Comments regarding the Chris Farley House redevelopment proposal

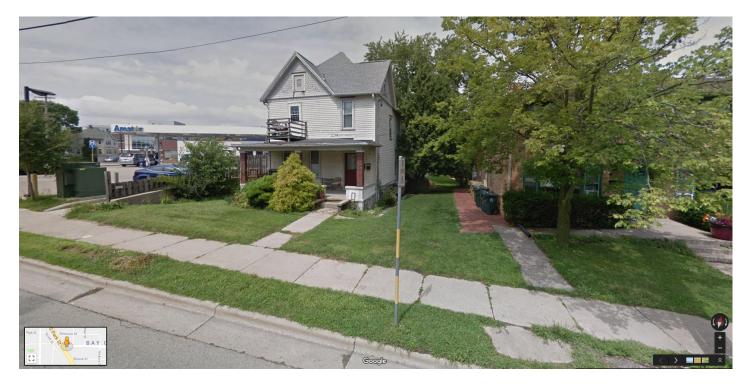
The west end of Olin Avenue is another story. The intersection with Park Street looks much the same as it did about a hundred years ago with the exception that Park Street has widened to four lanes and traffic signals were installed. The East end of Olin Avenue is notorious for its steep approach to Park Street. No doubt many drivers have killed their engines trying to get going from a dead start at this intersection ever since 1910 or so when mass production of automobiles made them affordable for the masses. Here is a picture of a previous gas station at 1129 S. Park Street. Behind the old automobiles you can see Olin Avenue's steep grade as it approaches Park Street.

Traffic Engineering has known of the issues with this intersection for years yet they have consistently ignored opportunities to improve the intersection in any meaningful way. Due to the grade issues at this intersection, either the elevation of the Olin Avenue approach to Park Street needs to be raised or the elevation of Park Street in the vicinity of this intersection needs to be lowered or a combination of both in order to design a safe and modern intersection at this location.
